SERVICE BULLETIN

No. 715A

Piper Aircraft Corporation

<u>Subject:</u>	Elevator Control Tube Inspection
<u>Reason for Revision:</u>	Add Affected Aircraft; revise Purpose; revise Instructions; add PART II; add Sketch.
<u>Models Affected:</u>	<u>Serial Numbers Affected:</u>
PA-31T Cheyenne/Cheyenne II	31T-7400002 through 31T-8120070
PA-31T 1 Cheyenne I	31T-7804001 through 31T-8104073
PA-31T 2 Cheyenne II XL	31T-8166001 through 31T-8166059, 31T-8166061 and 31T-8166062

SECTION A-A
SKETCH: BRACKET INSTALLATION

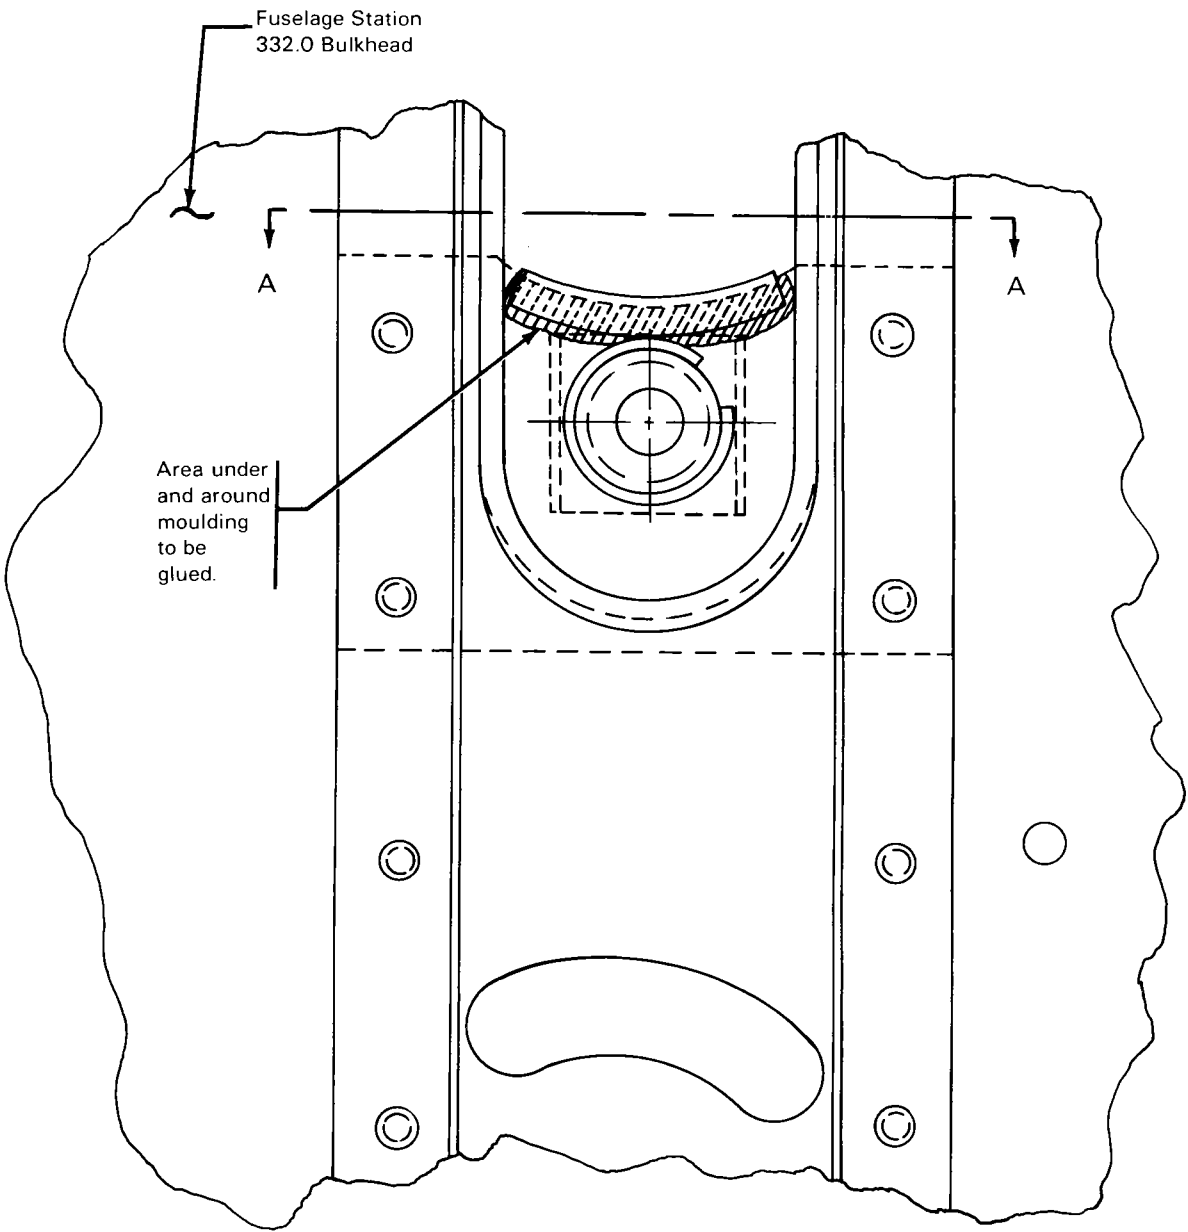
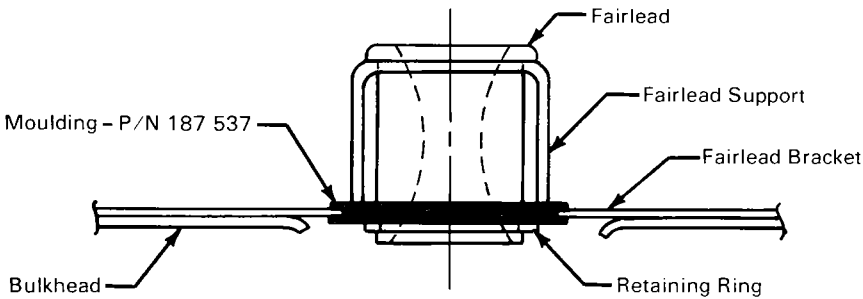
8. Reprime the elevator control tube.
9. At the bottom of the throughway in the Station 332.0 bulkhead, position the fairlead support, and file the fairlead bracket as shown in attached Sketch, Section A-A, to assure at least .125 inch clearance from the elevator control tube to the fairlead bracket after the protective moulding is installed.

10. With fairlead support as shown in Sketch, place a piece of rubber moulding, Piper Part No. 187 537, across the bracket.
11. Using existing hardware and bolt stops, reinstall the elevator control tube. While moving the elevator through its full travel, determine that the clearance between the control tube and the protective moulding does not decrease to less than .125 inch.

12. Using 3M EC847 adhesive or equivalent, glue the rubber moulding in place as shown in Sketch.
13. Check elevator controls for proper system operation and rigging. (Refer to Service Manual, Section V).

5. Reprime the elevator control tube.
6. At the bottom of the throughway in the Station 332.0 bulkhead, position the fairlead support and file the fairlead bracket as shown in the attached Sketch, Section A-A, to assure at least .125 inch clearance from the elevator control tube to the fairlead support bracket after the protective moulding is installed.

7. With fairlead support as shown in Sketch, place a piece of rubber moulding, Piper Part No. 187 537, across the bracket. Reinstall the control tube and insure that the clearance between the tube and the protective moulding does not decrease to less than .125 inch at any point in elevator travel.

8. Using 3M EC 847 adhesive or equivalent, glue the rubber moulding in place as shown in sketch.
9. Check elevator controls for proper system operation and rigging. (refer to Service Manual, Section V.)
